Department of Energy
Field Office, Albuquerque
Los Alamos Area Office
Los Alamos, New Mexico 87544

On September 30, 1993, this office received a Notice of Deficiency (NOD), dated September 28, 1993, for the Resource Conservation and Recovery Act (RCRA) Facility Investigation Work Plan for the Los Alamos National Laboratory Operable Unit 1098, with a list of deficiencies enclosed.

RFI Work Plan for Operable Unit (OU) 1098

Figure 7.5-1 Proposed SWMU no. 2-004, storage pits and tanks of the Omega West Reactor, RFI boring-soil sampling locations.

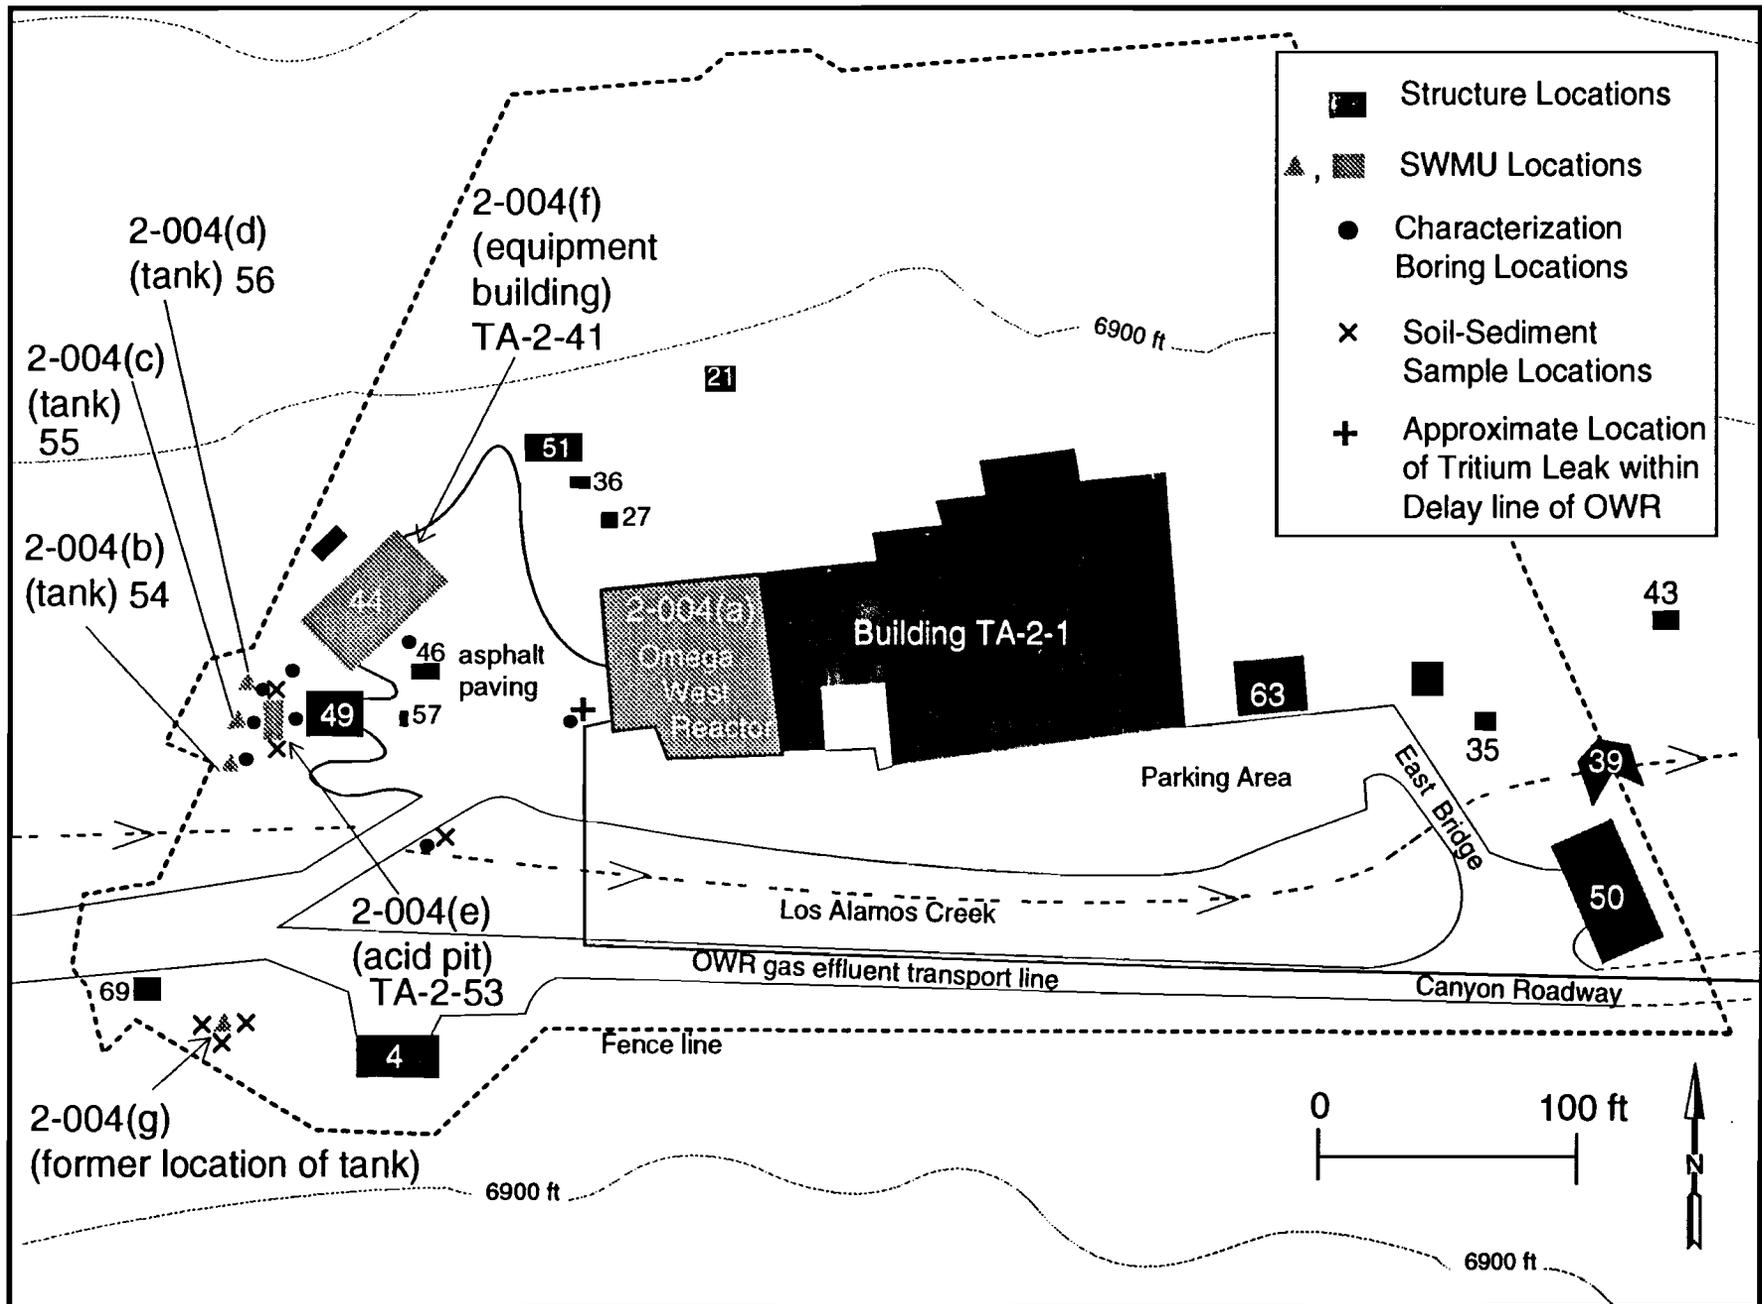
Comment 2. "7.5.3.2 Surface Sampling, p. 7.5-6 and 7.5.3.3 Subsurface Sampling, p. 7.5-7 -

- a. Surface and subsurface sampling should be for all RCRA metals using 6010 and not just chromium.
- b. If spills were common around the acid pit then more than 2 samples may be appropriate, and the subsurface borehole should probably be slanted under the pit."

Comment 2b, A total of five boreholes and two surface samples will be taken immediately adjacent to SWMU 2-004 (e) as shown in the revised Figure 7.5-1 (attached). The figure has been changed to label SWMU 2-004(e) as the Acid Pit. The number of samples proposed is judged to be appropriate to address the goal of confirming the presence or absence of contamination associated with this SWMU. If contaminants are confirmed, additional sampling will likely be appropriate in follow up characterization work. The two borings closest to SWMU 2-004(e) (North and South) will be slant-drilled in order to obtain samples from directly beneath the acid pit.

Figure 7.15-1 Proposed SWMU no. 41-002, sewage treatment plant, RFI boring-soil sampling locations.

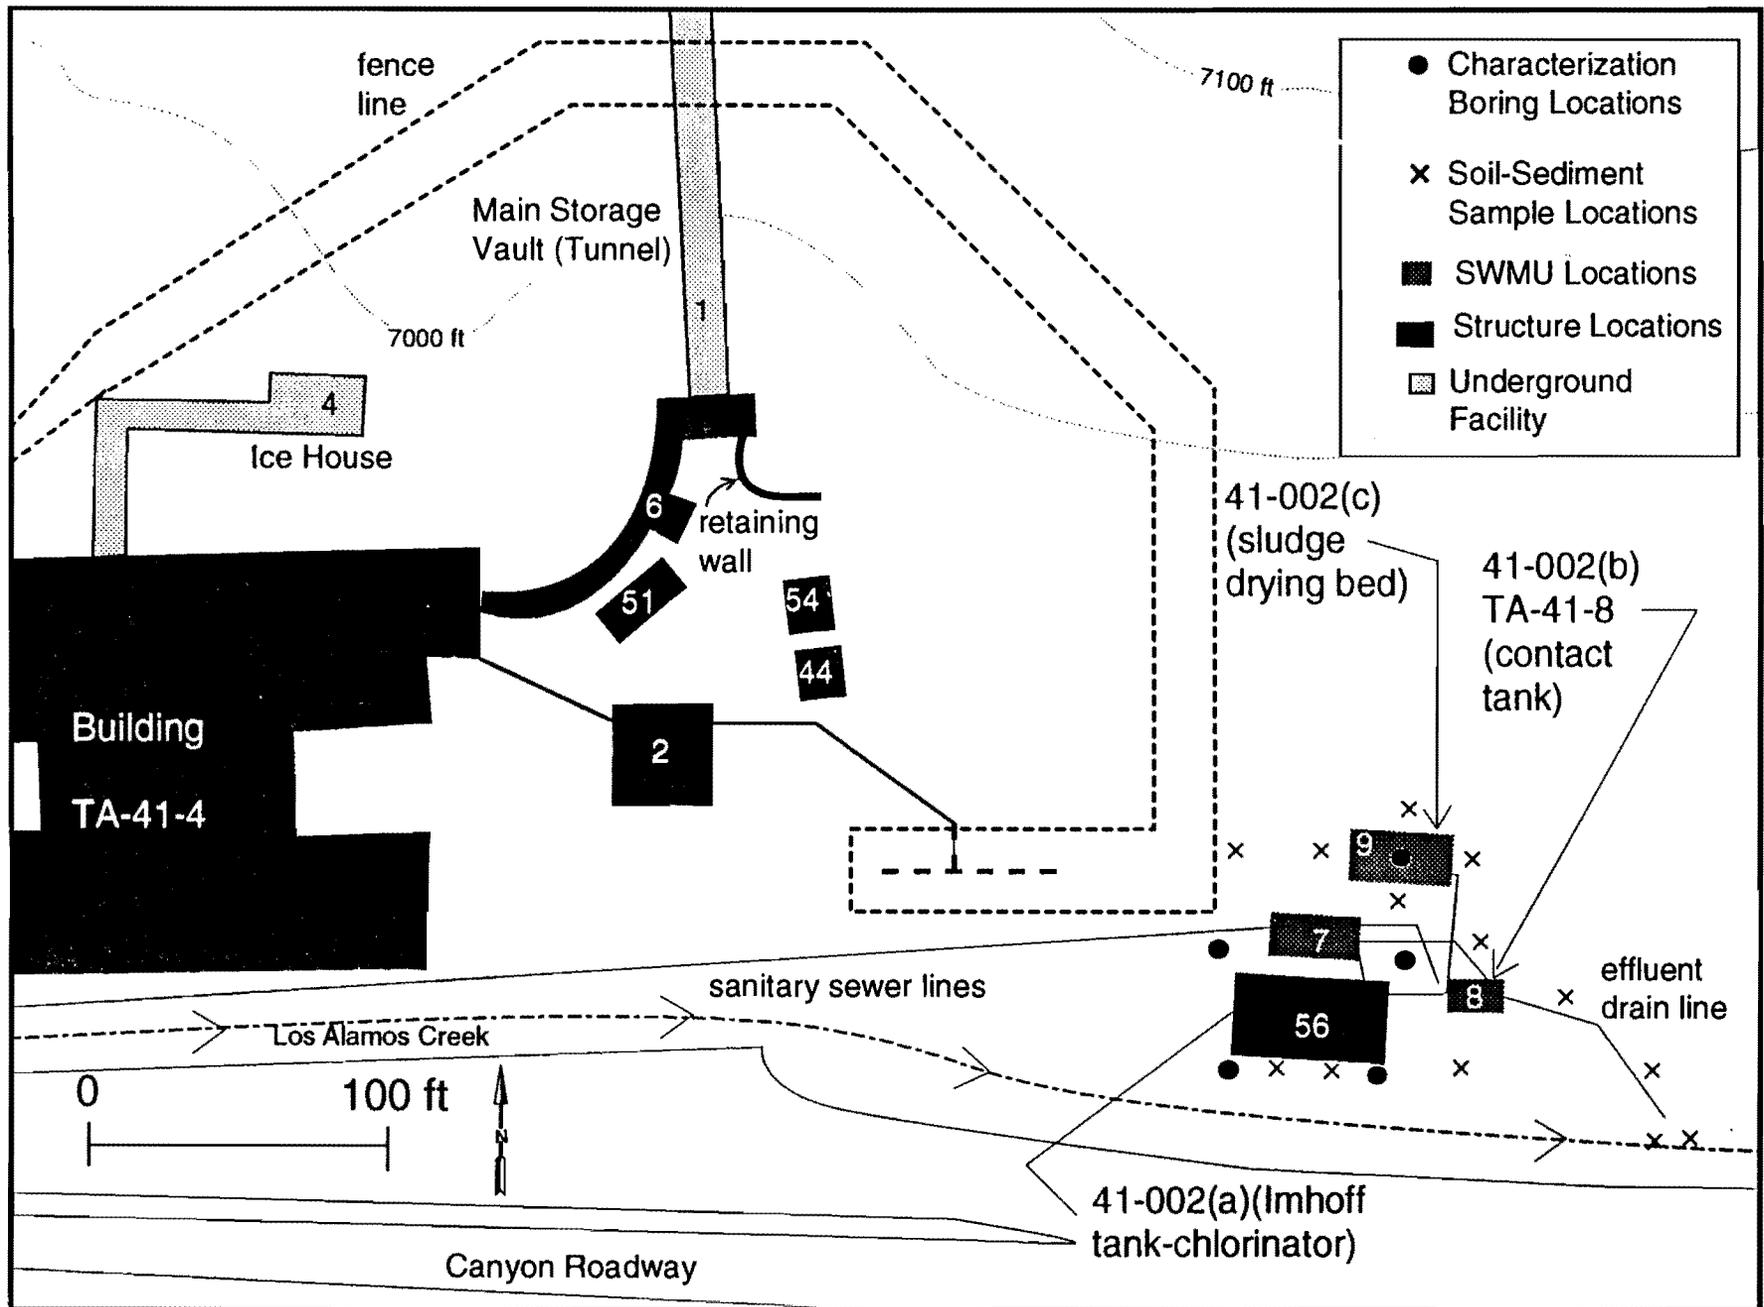
Comment 5. "7.15.3.2 Subsurface Sampling, p. 7.15-5 - Borings should be placed as close to SWMU 41-002(a) as possible, or angled under the tank to investigate for potential contamination."

Response: Boreholes will be placed as close to SWMU 41-002(a) as possible assuming that no radiological anomalies are found. If anomalies are found, then borehole locations will be adjusted in order to investigate the anomalies. Given that alluvial ground water exists at shallow subsurface depths of less than 20 feet with ground water flow velocities on the order of 1200 feet per year, and that contamination, if present, is likely to have spread due to interaction with this ground water, angled boreholes are not judged to be necessary for a phase I investigation that is only designed to confirm the presence or absence of contamination.
